3 Functional Description (cont'd) 3.1 Initialization (cont'd)

Figure 5 — Initialization Waveform Sequence

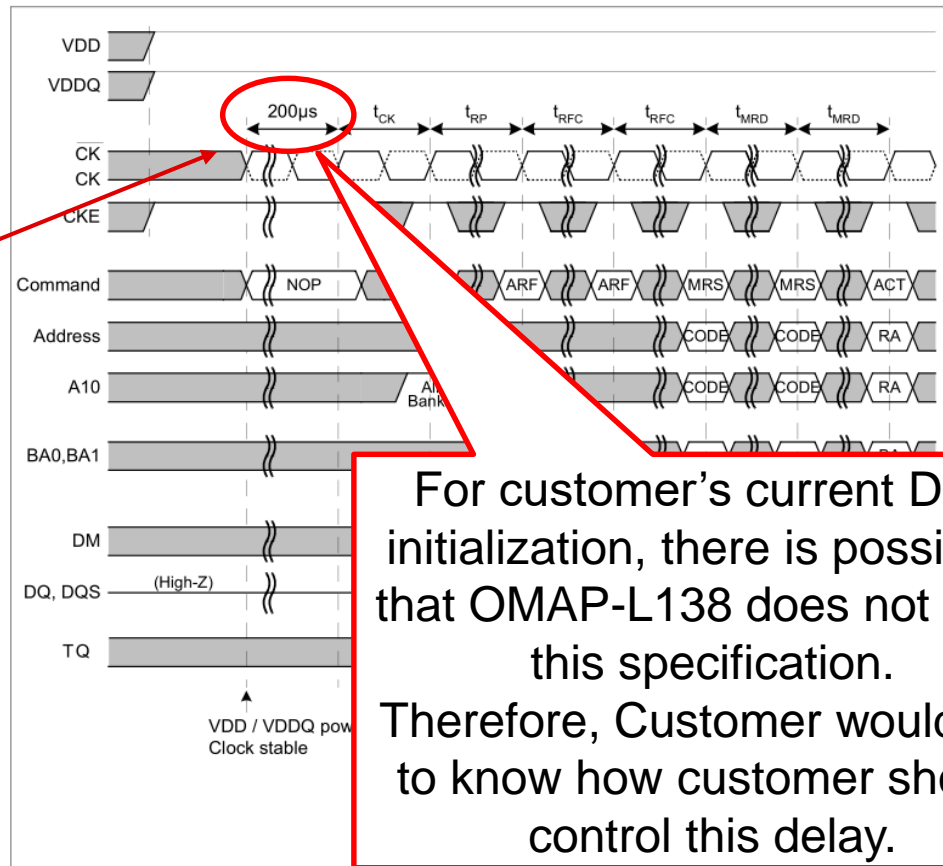
For customer's current DDR initialization, there is possibility that OMAP-L138 does not meet this specification. Therefore, Customer would like to know how customer should control this delay.
